Gateway Estates Unit One Replat M

City Plan Commission — December 18, 2025 (REVISED)

CASE NUMBER/TYPE:	**SUSU25-00103 – Resubdivision Final**
CASE MANAGER:	Saul Fontes, (915) 212-1606, FontesSA@elpasotexas.gov
PROPERTY OWNER:	GFA, LLC
REPRESENTATIVE:	CEA Group
LOCATION:	North of Vista del Sol Dr. and East of Joe Battle Blvd., Extraterritorial Jurisdiction (ETJ)
PROPERTY AREA:	28.11 acres
VESTED RIGHTS STATUS:	Not Vested
PARK FEES:	$152,070.00
ZONING DISTRICT(S):	N/A property lies within ETJ
RELATED APPLICATIONS:	SUSU21-00052 Gateway Estates Unit One Replat M

GATEWAY ESTATES
UNIT ONE REPLAT M

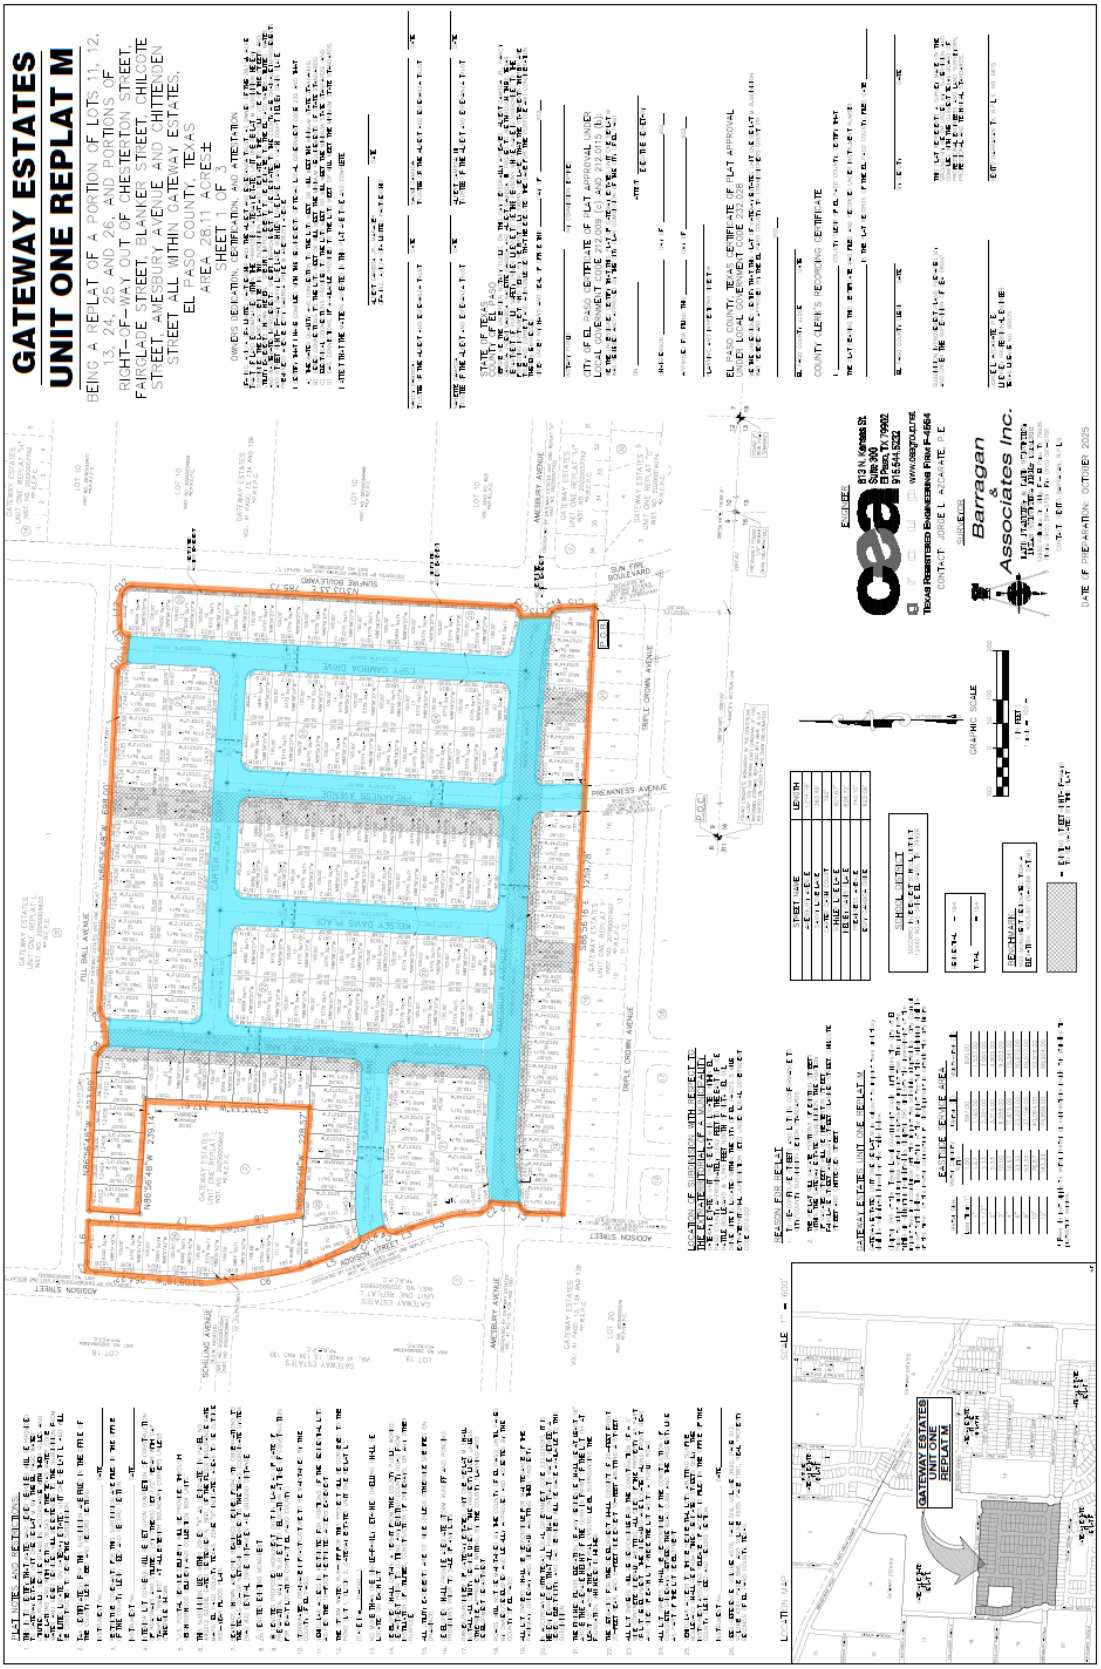
3. Revise citation of Local Government Code to "Location of Subdivision with Respect to the Extraterritorial Jurisdiction of Municipality" Site is located within the City of El Paso's 5-Mile Extraterritorial Jurisdiction (ETJ) under Local Government Code, Chapter 212

1. Detail, dimension, and tie location of city monument at intersection of Carter Cash Court and Schyller Love Lane.
2. Boundary closure report provided is ok.
3. Provide north arrow on location map key detail.

MAP OF TOPOGRAPHY AND DRAINAGE
MAPA TOPOGRAFÍA Y DE DRENAJE DE DE AGUA
SCALE 1"=200'

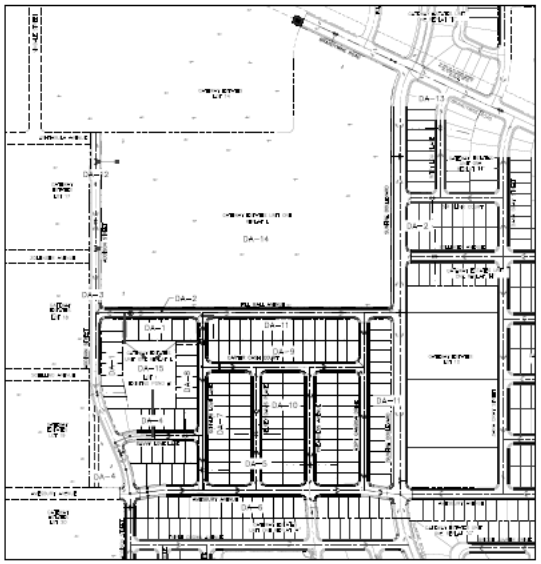
4. The drainage pond for Gateway Estates Unit One Replat L (SUSU21-00044) needs be constructed and accepted prior to or concurrently with Gateway Estates Unit One Replat M in order to adequately sustain the proposed subdivision pursuant to Section 19.03.040.D.
